Simulation result : Feedforward (AC-coupling) vs Feedback roop (AGC TIA)

Result and discussion

Feedforward model (AC-coupling)

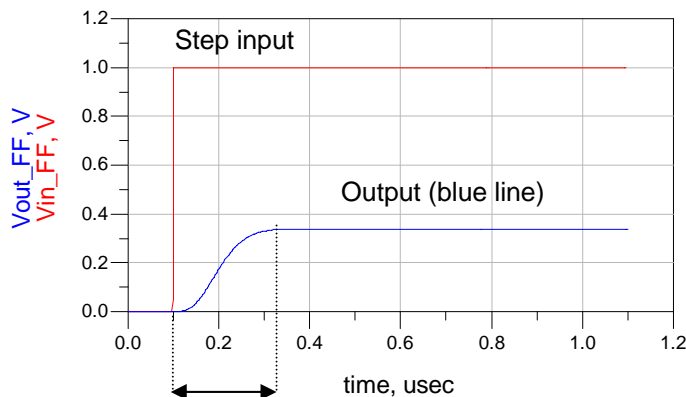
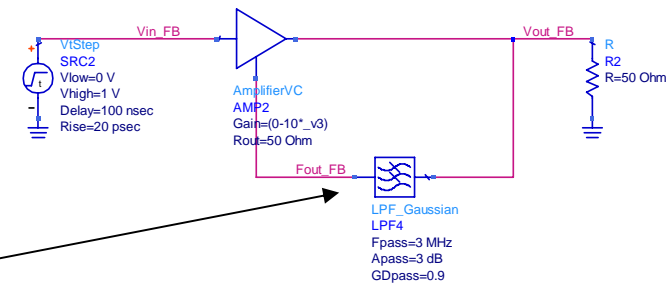
Shorter Burst overhead time < 150-ns

Feedback model (AGC TIA)

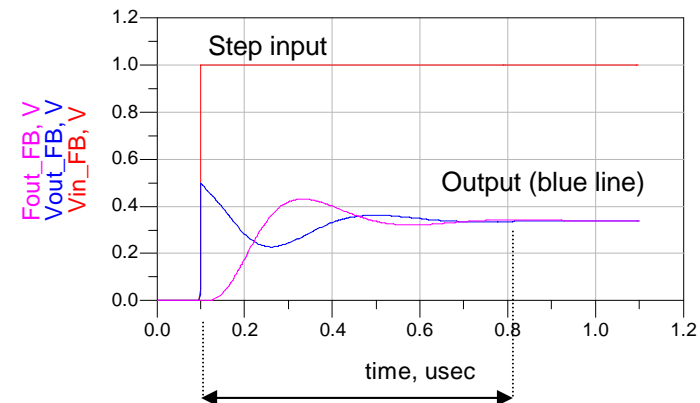
- Even when a feedforward equivalent AC coupling and a feedback based AGC TIA have the same time constant of LPF, the AGC TIA need a longer burst overhead time due to the roop convergence time.
- Generally, there is trade-off between the roop convergence time and the roop stability, and a lack of stability can induce penalties or self-oscillation at worst. Thus, we need enough roop convergence time for implementation.
- Although the required response time of AGC TIA is depend on circuit design, thorough my experience, I believe that the AGC TIA need about 5x or more longer time than that predicted value estimated by feedforward roop with the same time constant.

Longer Burst overhead time < 800-ns

So, I agree with the Hamano-san's proposal of Treceiver_setting = 800-ns (max)
